COMPONE	ENT CODE 79
PARTS & SERVICE	REF NO.	AT04823
NEWS	DATE	Jun. 4, 2004
		Page 1 of 5

SUBJECT: REPAIR PROCEDURE FOR TAIL GATE (OPTION) ON HM400-1

PURPOSE: To introduce modification procedure to replace the tail gate on HM400-1 articulated dump trucks with the improved parts (optional)

APPLICATION: HM400-1 Articulated Dump Trucks, Serial Nos. 1071 thru 1076 Serial Nos. 1087 thru 1088 Serial Nos. 1118 thru 1119

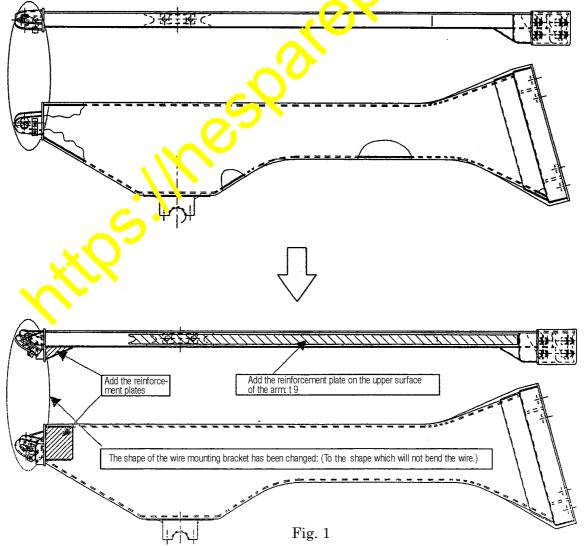
- 3. Details of the modification
 - (1) The mounting angle of the wire mounting bracket is changed to make a structure where the wire may be pulled straight forward when the body is raised to the stroke end.

The motion of the wire mounting brack t is changed so that the arm side bracket may be directed toward the frame side bracket when the body is raised to the stroke end.

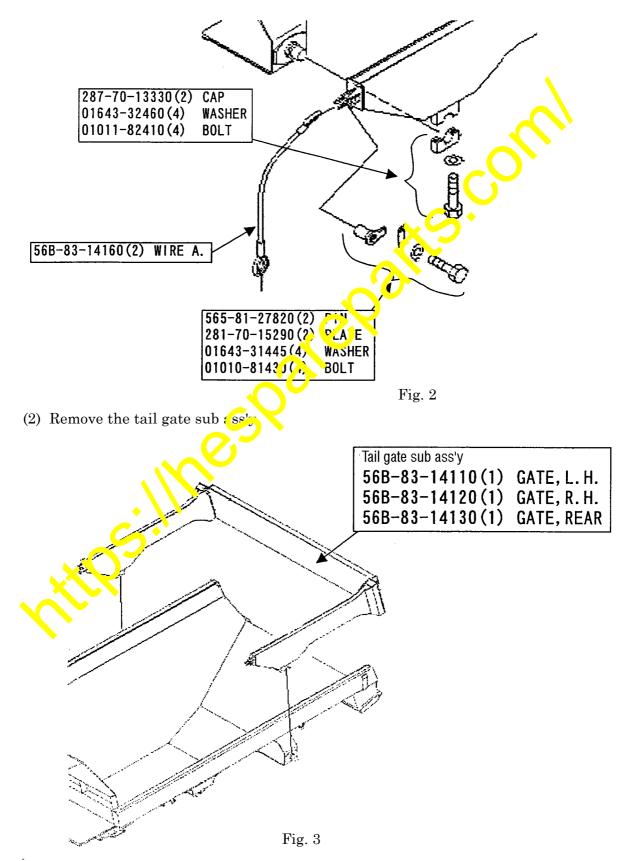
(2) To prevent the deformation of the arm, add the reinforcement plates to the upper surface and to the rear section of the wire mounting section to increase the rigidity.
